PCN1093

Detailed Description of Change

IXYS Integrated Circuits Division (ICD), now part of Littelfuse, has made a packaging change to the CPC3708CTR as described below:

Appendix 1

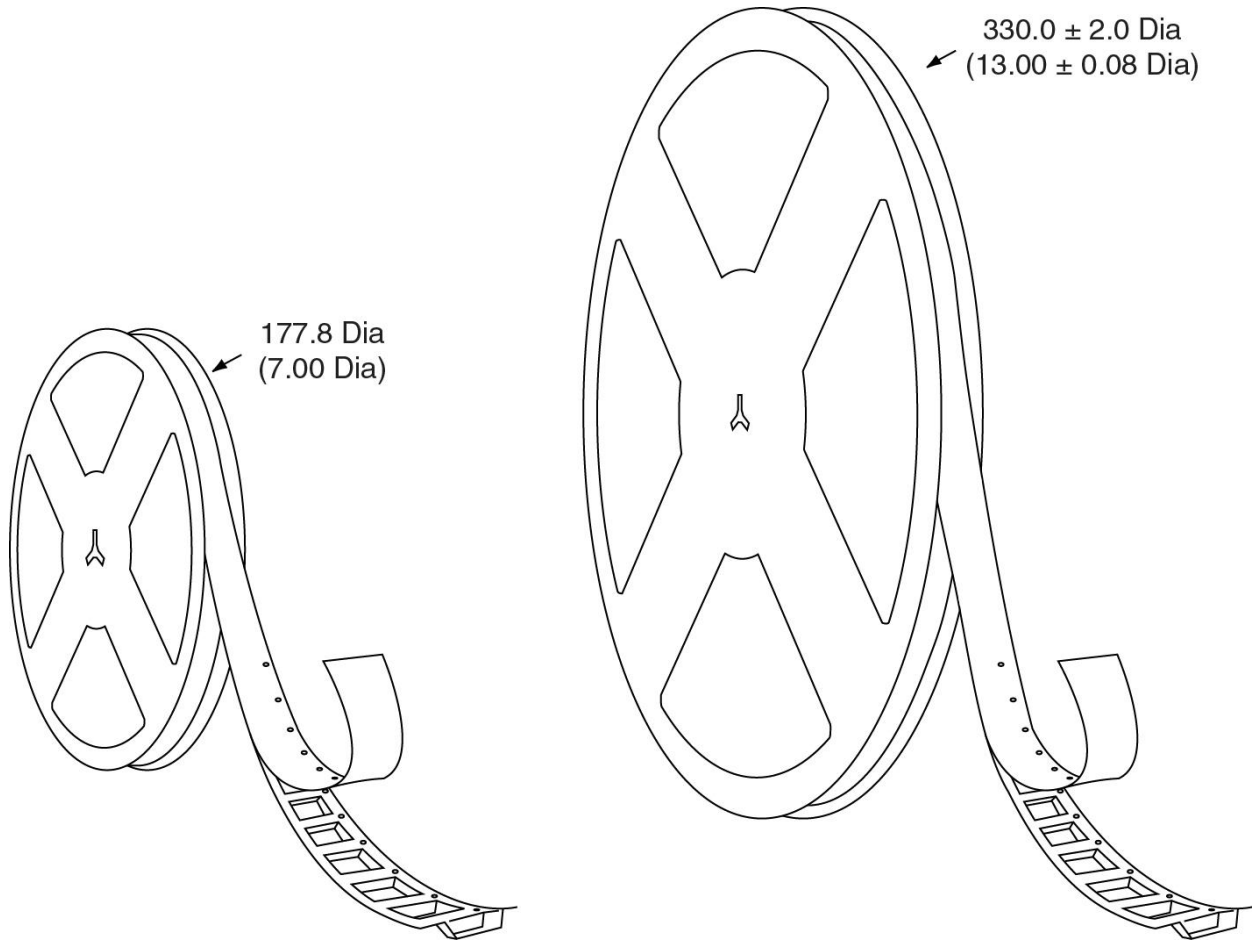
The reel diameter of the CPC3708 in the SOT-89 package, part number CPC3708CTR, is changing from 7 inches (1,000ea/Reel) to 13 inches (4,000ea/Reel). Please see Appendix 1 for a graphical representation of the change. Additionally, because the number of units supplied with the larger reel is increasing, the minimum orderable quantity will increase from 1000 to 4000.
